PROGNOSIS FOR
 CISCO DRILLING & DEVELOPMENT CO.
 CISCO #4 WELL
 NE. SW. SEC. 27-20S-23E
 GRAND COUNTY, UTAH

SURFACE USE & OPERATIONS PLAN
FOR
CISCO DRILLING & DEVELOPMENT CO.
CISCO #4 WELL
NE.SW.SEC.27-20S-23E
GRAND COUNTY, UTAH

STATE OF UTAH
DIVISION OF OIL, GAS AND MINING

ENVIRONMENTAL IMPACT ANALYSIS - ATTACHMENT 2-B

WESTERN ENGINEERS, INC. WELL LOCATION CISCO DRILLING AND DEVELOPMENT CO CISCO NO. 4 GRAND COUNTY, UTAH <hr/> SURVEYED <u>D.L.B.</u> DRAWN <u>R.W.G.</u> GRAND JUNCTION, COLO. 11/1/77
--

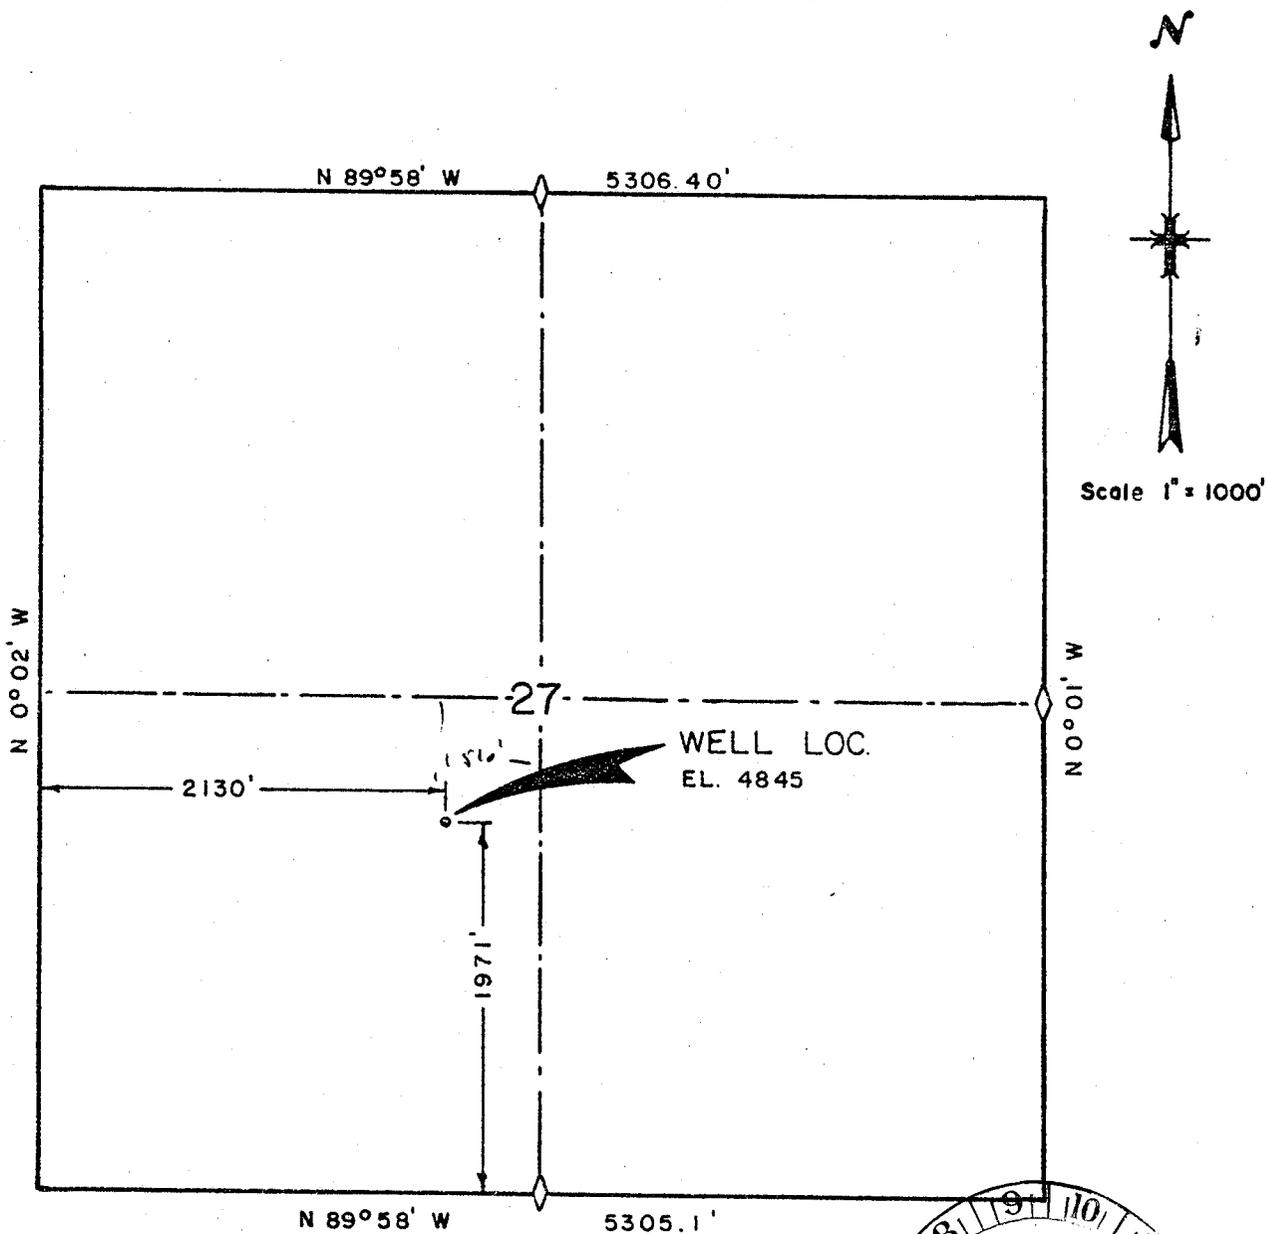
Note: ① Amt Surface esp - Should be
200' & 100SX.

Insofar as this office is concerned, approval to drill the above referred to well is hereby granted in accordance with the Order issued in Cause No. 102-5. However, please be advised that this office is requiring a minimum of 200 feet of casing be set with 100 sacks of cement in this area.

Also, it was noted on your amended application that the amount of surface casing was unchanged. Please refer to our original letter of approval in which you are to set a minimum of 200' of surface casing.

This office approves the new location of Cisco #4, being 1971' FSL & 2250' FWL, Section 27, T. 20S, R. 23E, provided that a survey plat indicating the new location be submitted to this office.

LOCATION PLAN FOR
 CISCO DRILLING & DEVELOPMENT CO.
 CISCO #4 WELL
 NE.SW.SEC.27-20S-23E
 GRAND COUNTY, UTAH

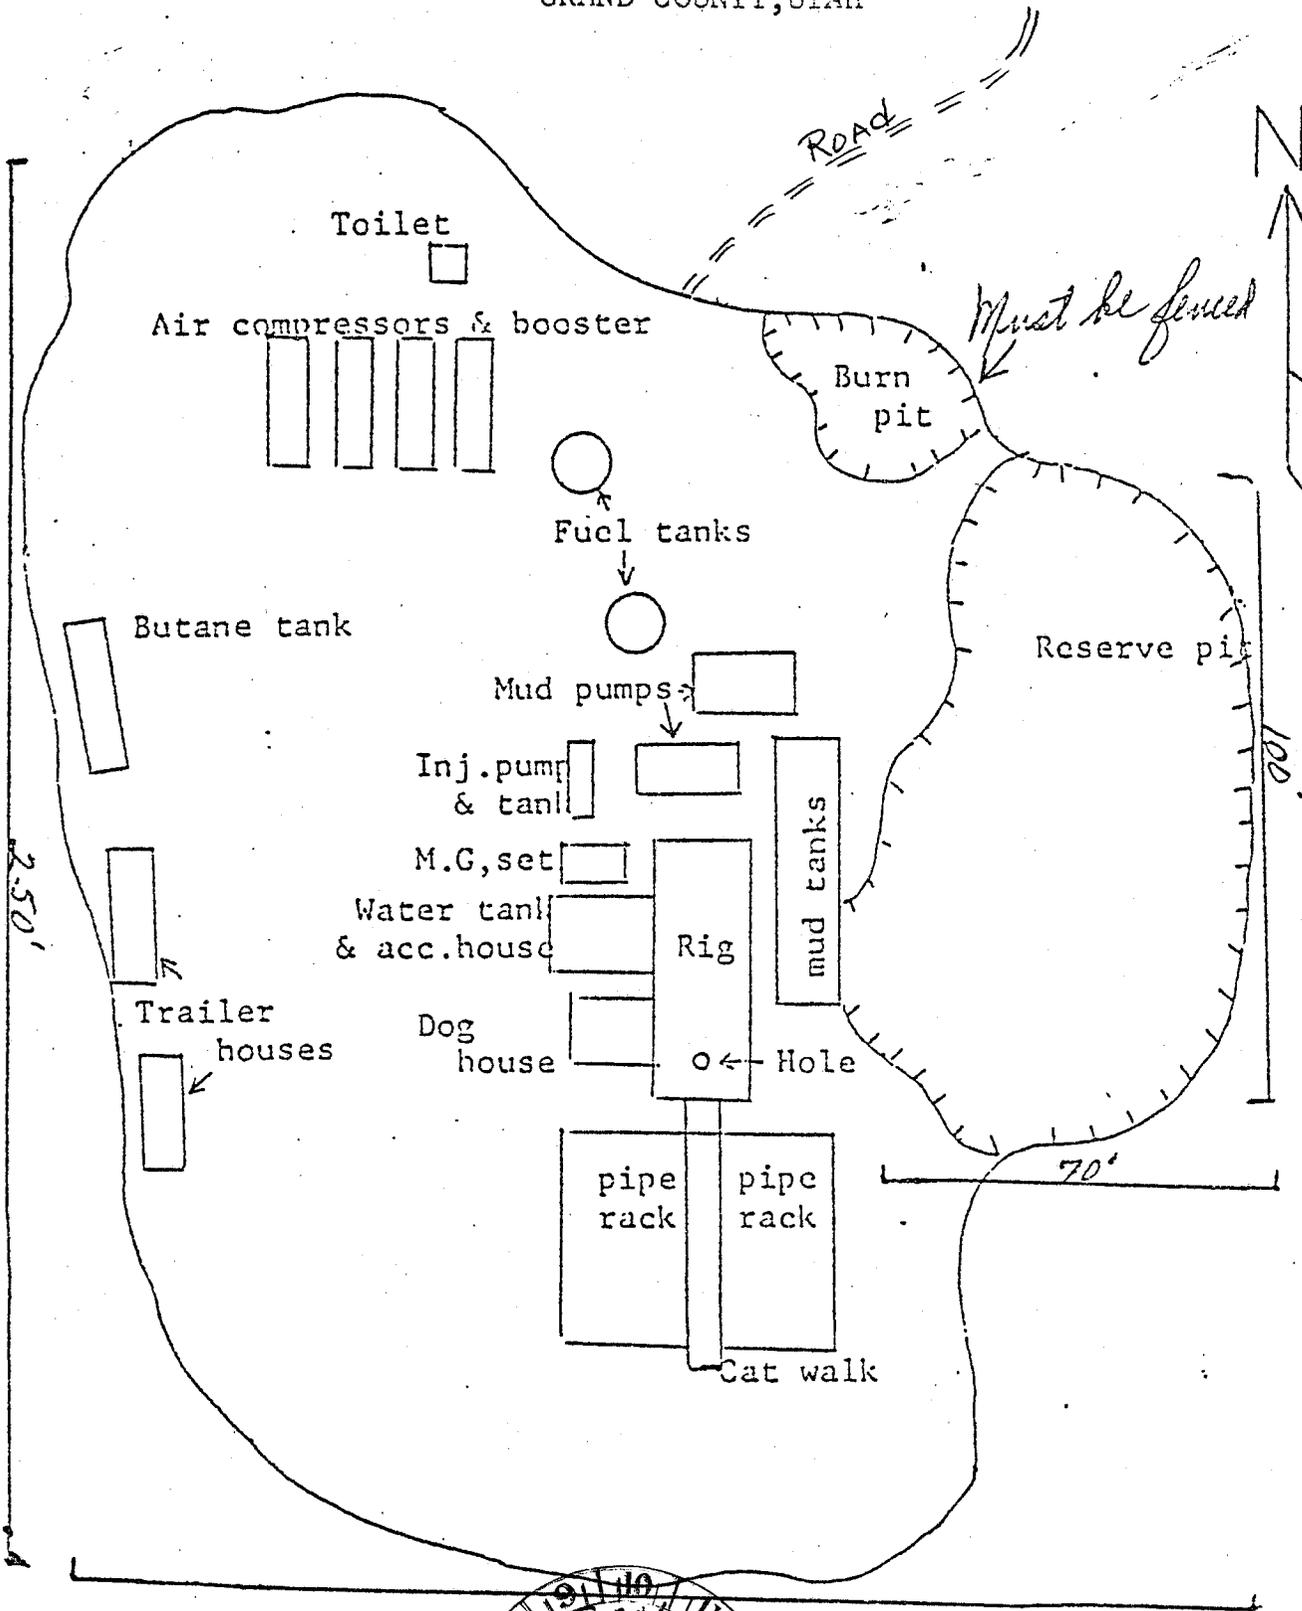
IF ^{CANNOT} get State approval for well being to close (less than 200') to $\frac{1}{4}/\frac{1}{4}$
Line, it is possible by stringing rig out in a odd

Shape, the original well site may be used. This may
present unexpected results when crews are ~~use~~ familiar with
standard set ups.

Also AREA of operations would be very cramped,
I don't recommend this alternative nor does operator -

3) LOCATION WAS MOVED 120' E TO AVOID LARGE SIDEHILL CUTS NATURAL DRAINAGE OTHER Cliff's, pad would extend over edge requires cuts & fills and cramped operating space. NEED state approval.
4) chemical toilet recommended for Human Waste

WESTERN ENGINEERS, INC.
WELL LOCATION
CISCO DRILLING AND DEVELOPMENT CO
CISCO NO. 4
GRAND COUNTY, UTAH
SURVEYED <u>D.L.B.</u> DRAWN <u>R.W.C.</u>
GRAND JUNCTION, COLO. 11/1/77

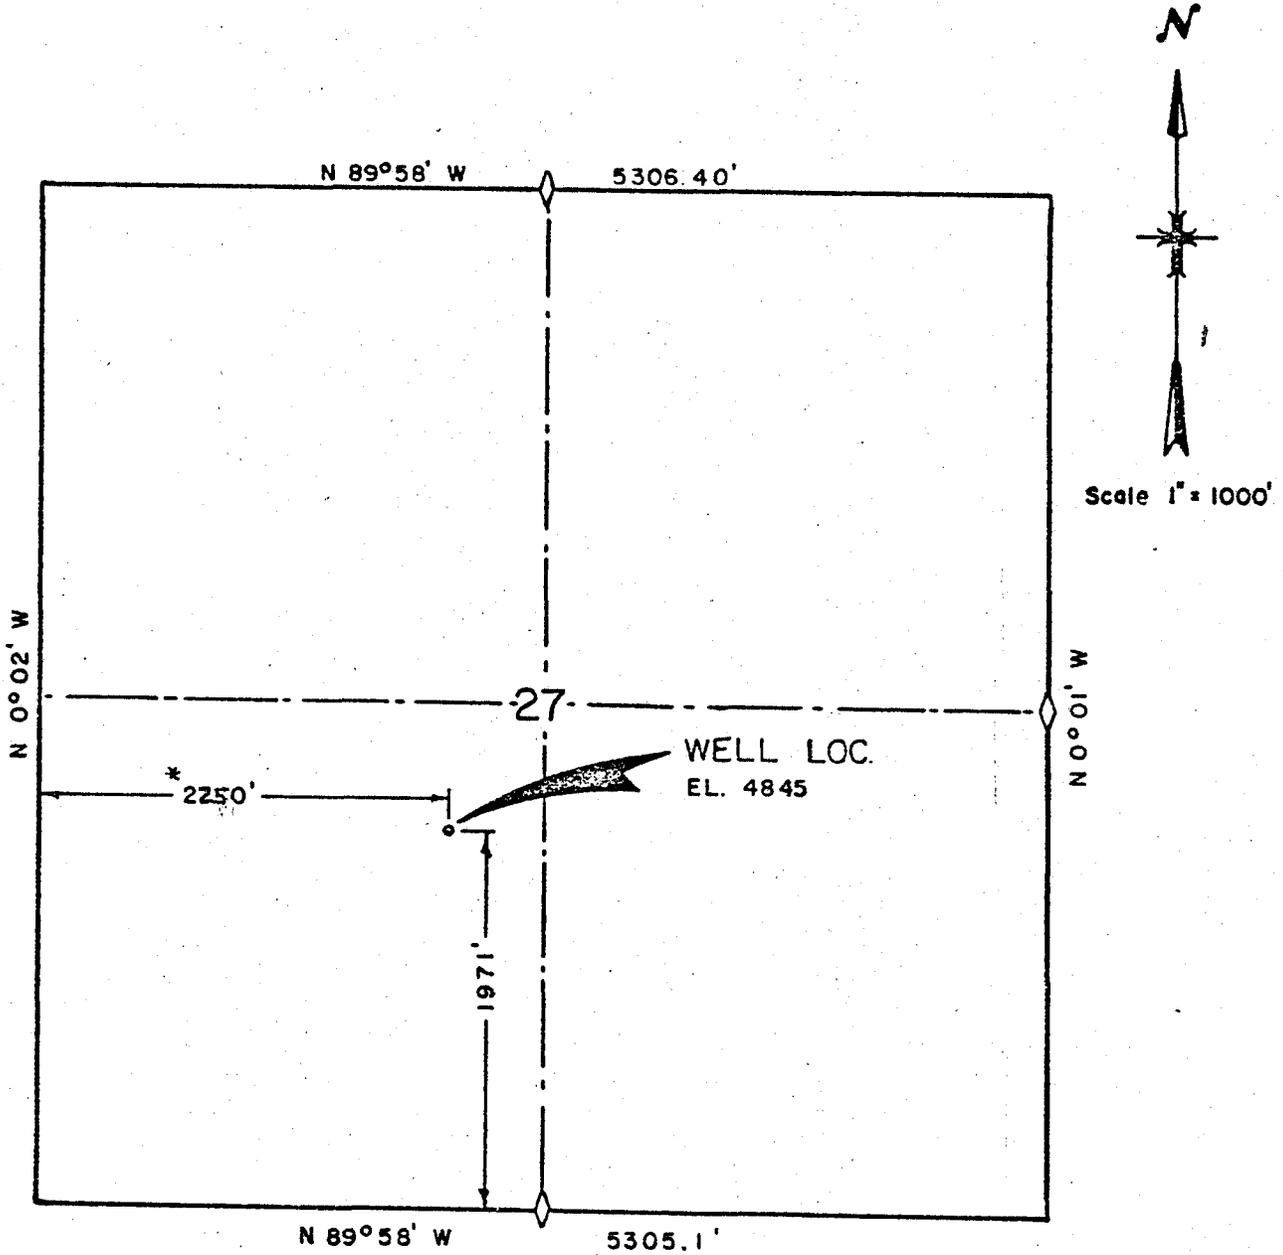
It is therefore requested that an exception to Rule 3 be granted on the basis of topographic reasons. The well site is on a narrow topographic peninsula which is quite limited in space. An amended permit to drill is enclosed.

** Location & plat
 changed to new site
 H. Don Gingley*
